# PREVOST

## Warranty Bulletin

## 97-05

Date: March 1997  
Section: 22  
Subject: THERMOSTAT RELOCATION  
Application:

FIGURE 1: H3-45

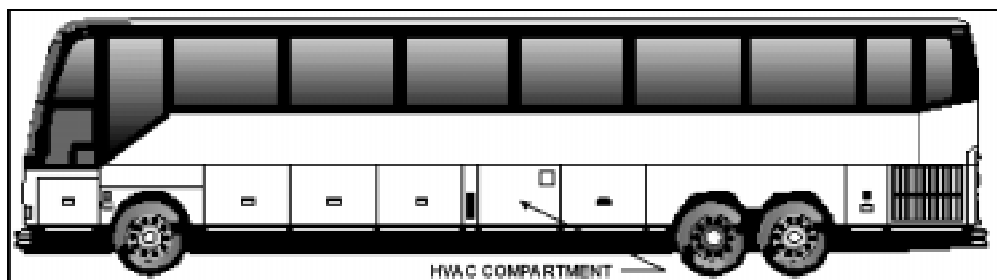
1. Open the HVAC compartment door (refer to fig. 1).

FIGURE 2: THERMOSTAT INSTALLATION IN HVAC COMPART. 22108

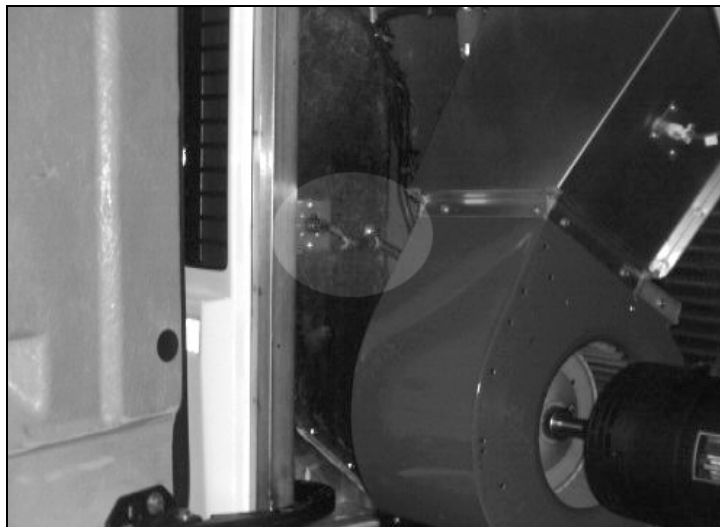
3. Disconnect C151 connector from wire of former thermostat. Connect C151 connector to the specified connector of extension wire (Prévost #064506) and the remaining connector to the thermostat. Cover the extension wire with a protective sheath.
4. Secure the thermostat connectors using a tie-cable (tie-wrap), use a clamp and a screw to secure the extension wire (refer to fig. 3).
